Access Compliance Report

Public Rights-of-Way

(Curb Ramps)

Intersection ID: 28724	Main Street: NORTHWOODS_FOREST_DR	Cross Street: LAWING_SCHOOL_RD	Location: S
ADA ID: F813B6EB1EE1	Ramp Type: Perp	Initial Pass/Fail: Fail	Overall Compliance: No
Codes/Mitigation Info/Possible Solution			Severity Score: 10
Field Measurements/Component Compliance

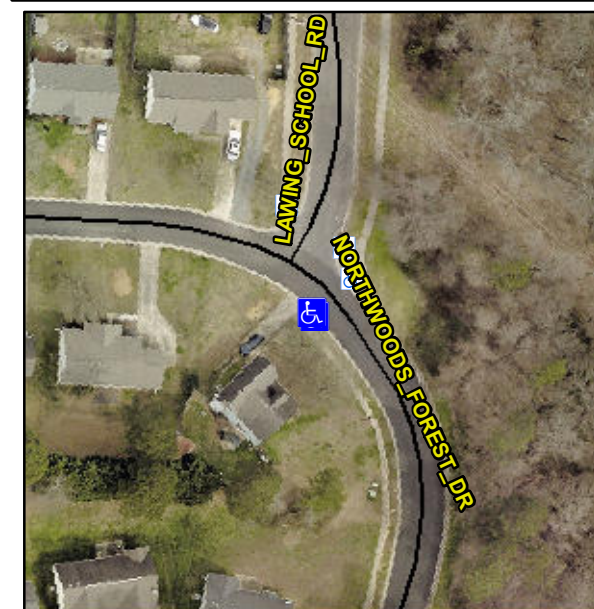
Not Found, R304.5.1, R304.5.3

Compliance	Description	Data	Compliance	Description	Data
N/A	Ramp Length (in)	48.0	Yes	Ramp Slope (%)	6.1
No	Ramp Width (in)	47.5	No	Ramp XSlope (%)	2.6
N/A	Flare Type LT	N/A	N/A	Flare Type RT	N/A
N/A	Flare Slope LT (%)	N/A	N/A	Flare Slope RT (%)	N/A
N/A	Flare Traversable LT?	N/A	N/A	Flare Traversable RT?	N/A
N/A	Landing Length (in)	N/A	N/A	DWS Provided?	N/A
N/A	Landing Width (in)	N/A	N/A	DWS Contrast?	N/A
N/A	Landing Slope (%)	N/A	N/A	DWS Length (in)	N/A
N/A	Landing X Slope (%)	N/A	N/A	DWS Full Width?	N/A
N/A	Landing Curb? (Y/N)	N/A	N/A	DWS Offset (in)	N/A
N/A	Shared Landing?	N/A			
N/A	Gutter Ponding?	N/A	N/A	Gutter Slope (%)	N/A
N/A	Gutter Lip Ht (in)	N/A	N/A	Gutter X Slope (%)	N/A
N/A	Painted X Walk1?	No	N/A	Painted X Walk2?	N/A
	X Walk 1 Direction	To NE		X Walk 2 Direction	N/A
N/A	X Walk 1 Width (in)	N/A	N/A	X Walk 2 Width (in)	N/A
	X Walk 1 Slope (%)	1.7		X Walk 2 Slope (%)	N/A
	X Walk 1 X Slope (%)	0.4		X Walk 2 X Slope (%)	N/A

Remove & Replace Entire Ramp.
